APPARATUS AFFECTED: All 33 Call Control Units except UCC21 and UCC22.

PART AFFECTED: TP178831 Receptacle Connector
TP178832 Adapter Plate
TP181240 Screw W/Lockwasher
TP182710 Upper Bracket
TP186426 Bracket
TP186628 Upper Bracket
TP197078 Mounting Plate
TP319258 Mounting Plate

REASON: (1) To conform to latest Underwriters Laboratories requirements.

NEW

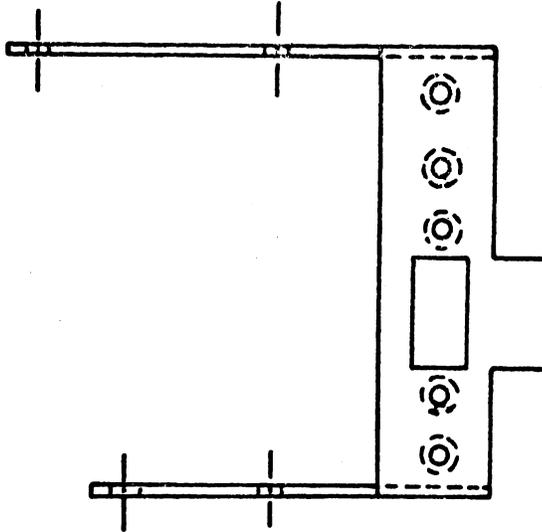
(1A) The TP178831 receptacle connector and TP178832 adapter plate are replaced by a new TP301713 receptacle connector. The TP182710 upper bracket is replaced by the new TP186628 upper bracket. The two TP181240 screws w/lockwashers which mount the above receptacle connector and adapter plate to the old TP182710 upper bracket are removed.

TP301713 RECEPTACLE CONNECTOR

NEW TP186628 UPPER BRACKET

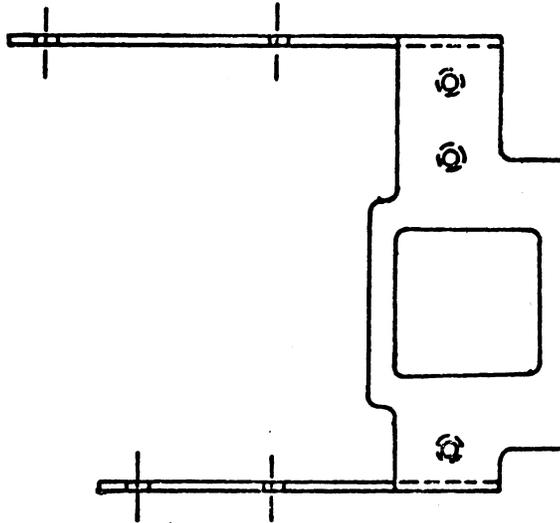
INTERCHANGEABILITY: Old and new parts are interchangeable as sets. The TP178831 receptacle connector and TP178832 adapter plate must be used with a TP182710 upper bracket. The new TP301713 receptacle connector must be used with the TP186628 upper bracket.
